**To the Planning Inspectorate.  
Deadline 10 submission.**

Response to Applicants' Comments at Deadline 9 ( REP9-025). to Deadline 8 Written Representation. (REP8- 046).

My Reference: EA1N. IP: 20024031/ AFP: 132. EA2. IP: 20024032/. AFP: 0134.

( Figure 3 below. ).

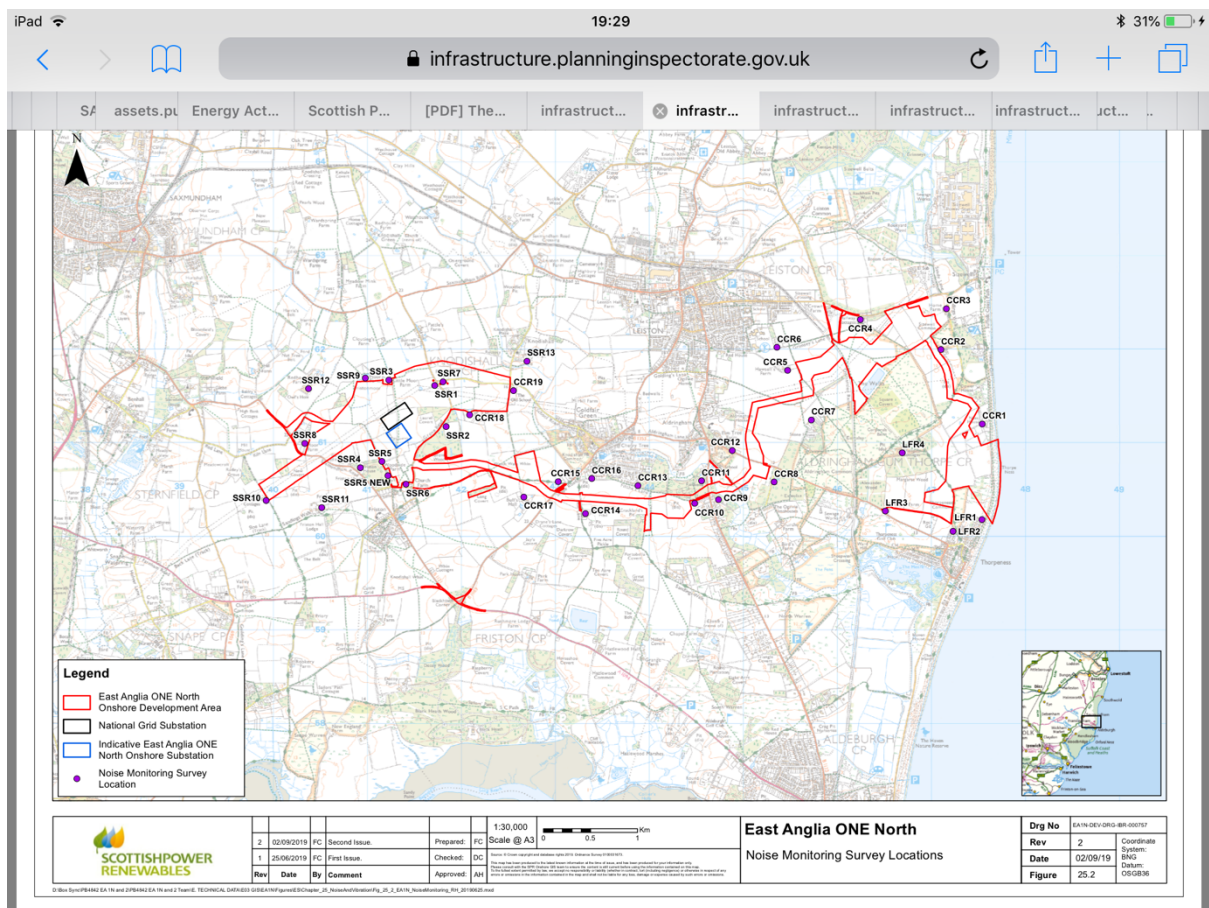
However, on Figure 25.2 ( APP-305) dated 4.3.21 The Applicants clearly show CCR1 at the west of [REDACTED].

The information communicated to me has clearly been provided by SPR to Mr. Jennings. If there has been miscommunication, therefore, it originates with SPR and is confirmed in the inaccurate information provided on the Figure.

2.1.9 Courtyard Cottage may have been “identified” by the Applicants as the “address closest to CCR1 on ( the) Table. However, it’s easy to see that it isn’t. [REDACTED] is. This may mean that the Applicants believe the Noise surveys were carried out at Courtyard Cottage, as their Table attests, and that their own maps showing them to have been at [REDACTED] identified on Gimson land are incorrect, or that the maps are correct, but for some reason the address at which they are actually located is disregarded in favour of a more distant address which shares the same postcode.
